### Section 33.2.4.5

### Add Section 33.2.4.5a Counters

tovl\_d\_counter

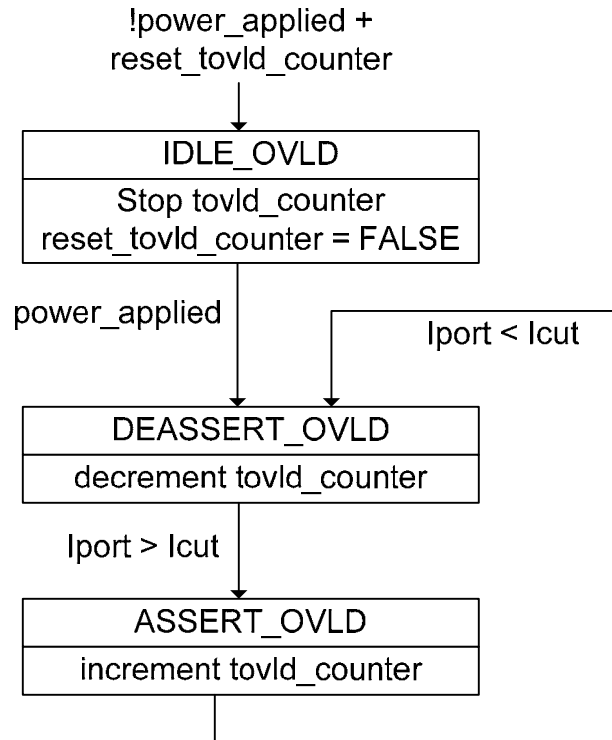
When “increment tovl\_d\_counter” is asserted, the counter increments by 20 counts every ms. When “decrement tovl\_d\_counter” is asserted the timer decrements by 1 count every ms. When “decrement tovl\_d\_counter” is asserted and the value of the counter equals 0, the counter stops counting. The counter is reset to 0 and counting stops when “stop tovl\_d\_counter” is asserted. “tovl\_d\_counter\_done” is asserted when the value of counter equals  $20 \times T_{ovld}$  (see Table 33-11) and remains asserted until the counter is reset. At all other times, “tovl\_d\_counter\_not\_done” is asserted.
